Product Change Notification (PCN)

- We found there are some typo on 5054330003-SD. We notify about correcting the following misdescription on the drawing.
There is no change to the product itself, so there is no impact to Form, Fit or Function.
- Objective Drawing number: 5054330003-SD PSD 000
 - Current Revision: Rev. A
 - After Revision: Rev. B
- Change point on the drawing

Change Point : Plating information and Part number

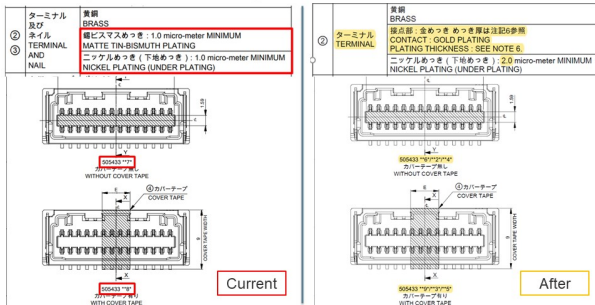
Change point	Current description	After description
Plating of Terminal	MATTE TIN-BISMUTH PLATING	GOLD PLATING
Under Plating of Terminal	1.0 micro-meter MINIMUM	2.0 micro-meter MINIMUM
Part Number	505433 **7*, 505433 **8*	505433 **6*, 505433 **2*, 505433 **4*, 505433 **9*, 505433 **3*, 505433 **5*,
